July 2, 2020

Having examined the draft Integrated Resource Plan (IRP) prepared by Siemens, SACE now offers the following comments to inform the process moving forward.

A. Siemens and MISO make a strong case for MLGW to leave TVA

Exhibit 62: Small Modular Reactor (SMR), All-In Capital Cost, 2018\$/kW

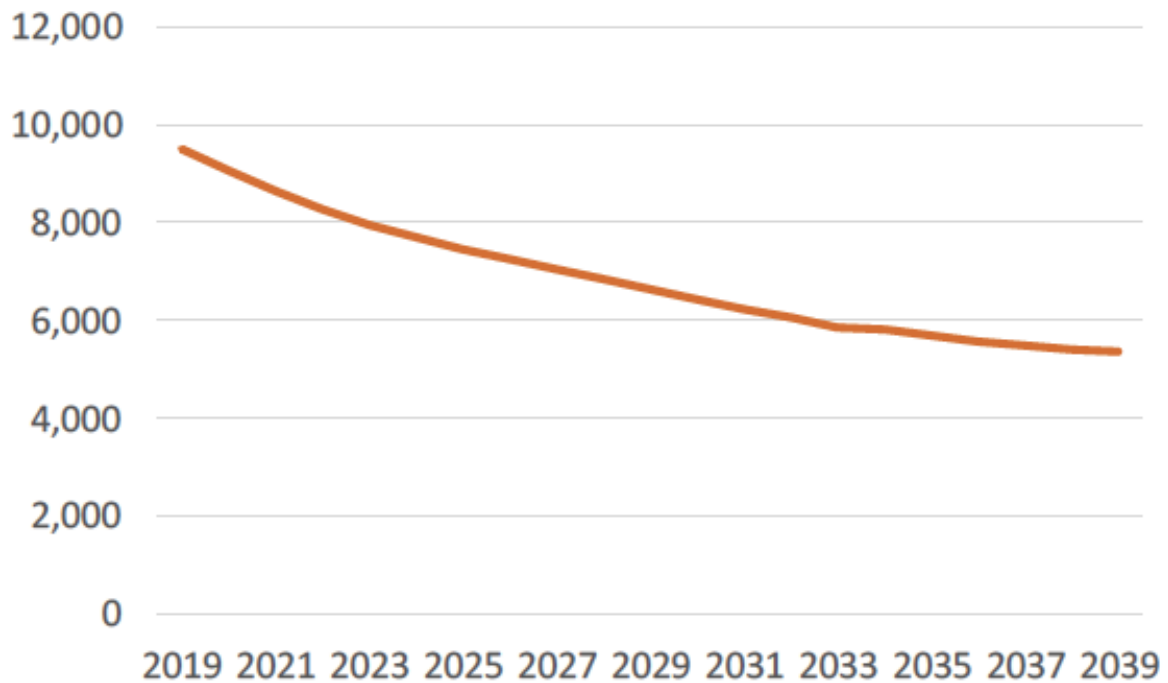
2. Nuclear (Small Modular Reactor) costs seem artificially low

On the other hand, Siemens’ assumptions for the cost forecast of Small Modular Reactor (SMR) technology exhibit annual cost declines while SACE has witnessed the cost of other nuclear technologies to be increasing rather than decreasing. (p. 87)

Exhibit 97: CO₂ Price Distribution (2018\$/ton)

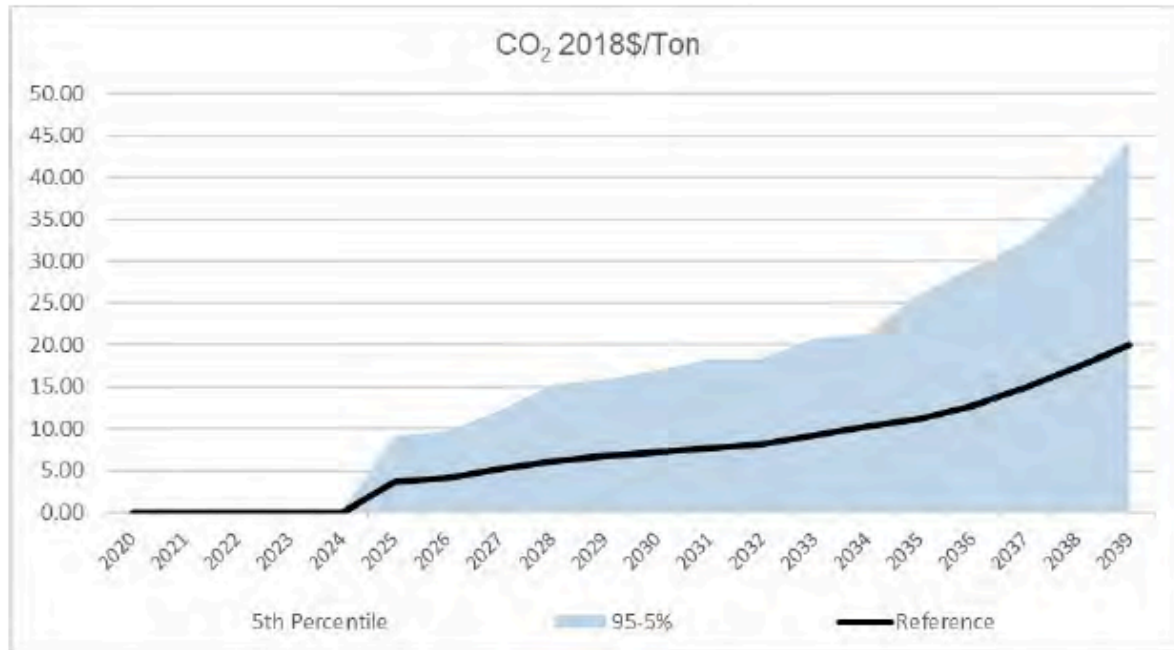
3. CO₂ pricing is low (and other GHG emissions are ignored completely)

SACE is pleased that Siemens enabled the modeling to include a CO₂ Emission Price (i.e., a cost for carbon). However, we contend that the values being modeled are very conservative. That price is presumed to start at \$3/ton in 2025 and escalate to \$20/ton over the next 15 years (in 2018\$). Even the high end of the stochastic uncertainty distribution only reaches \$45/ton by 2039 -- and the low end of that stochastic range reflects \$0/ton (p. 144).
